Synopsis of amendment

Response to the rejection under 35 USC 102(b)

FIG. 4

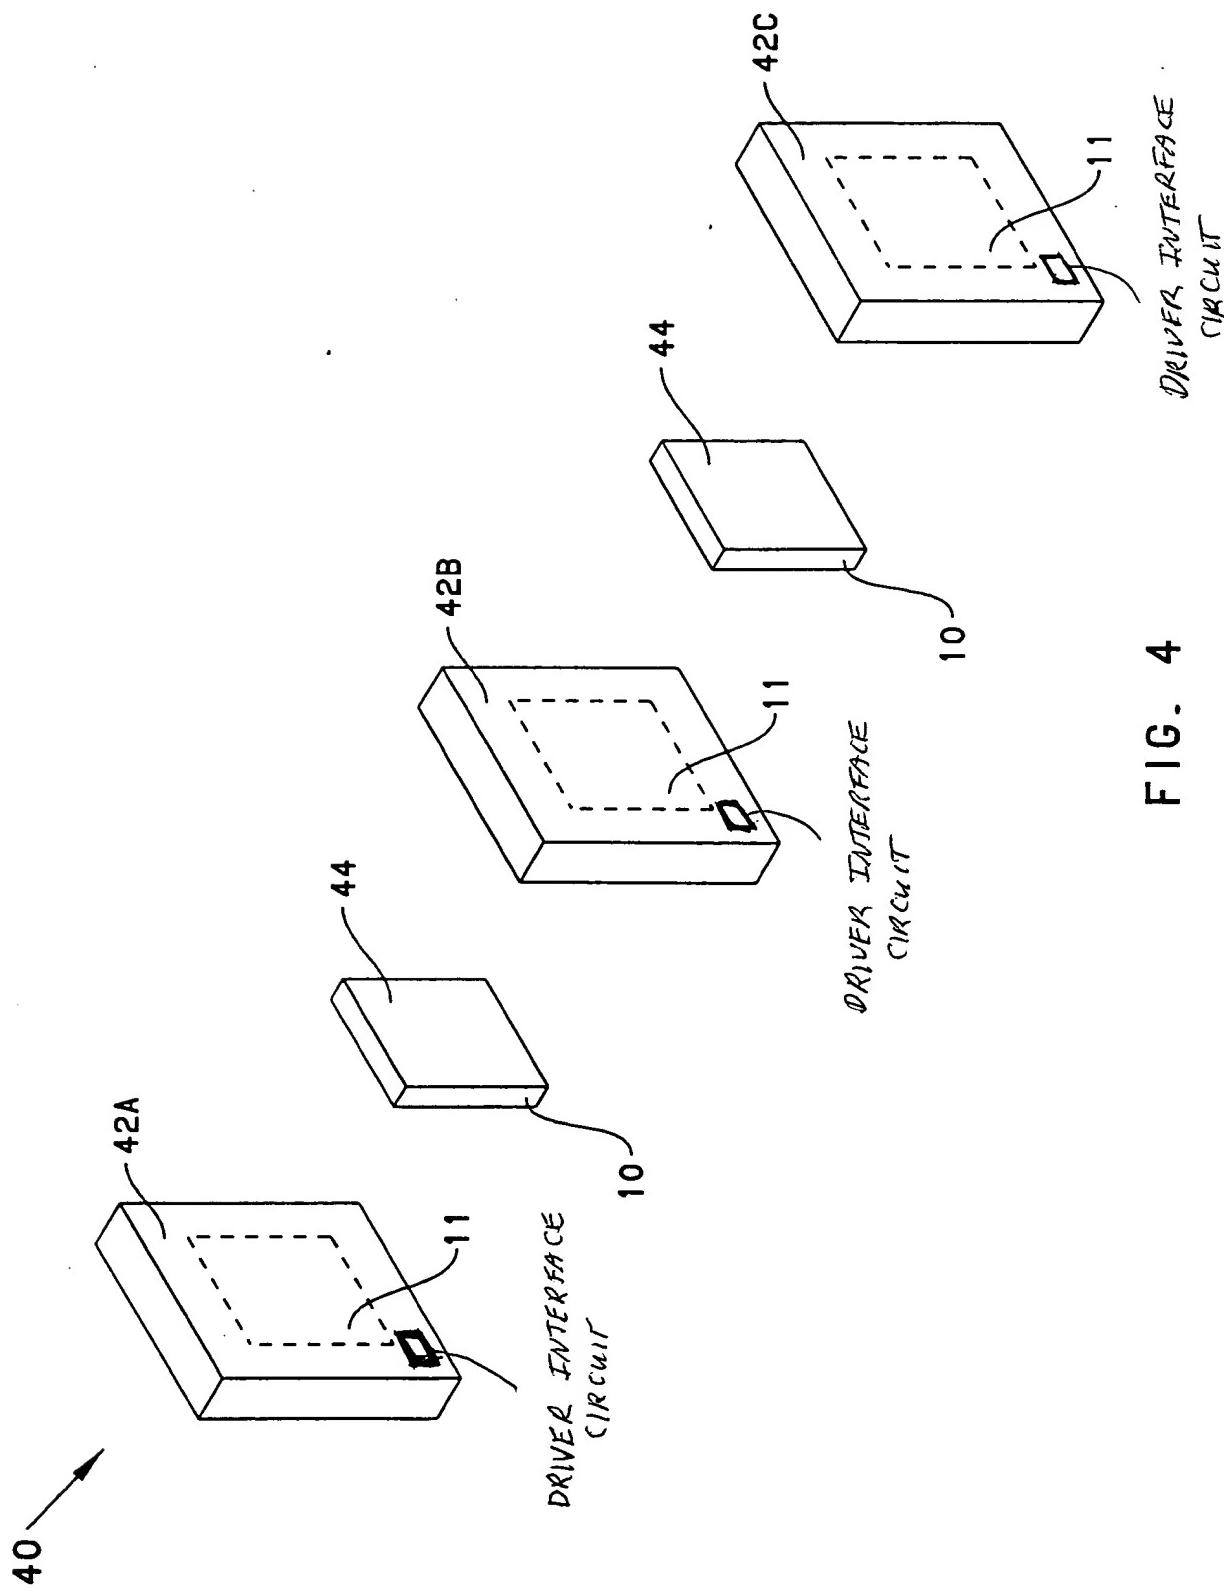
The drawings were objected to under 37 CFR 1.83(a) for not showing the claimed features of the electronically programmable driver and interface circuitry.

A proposed change to Fig. 4 is attached to further illustrate the claimed driver and interface circuitry described in the specification.
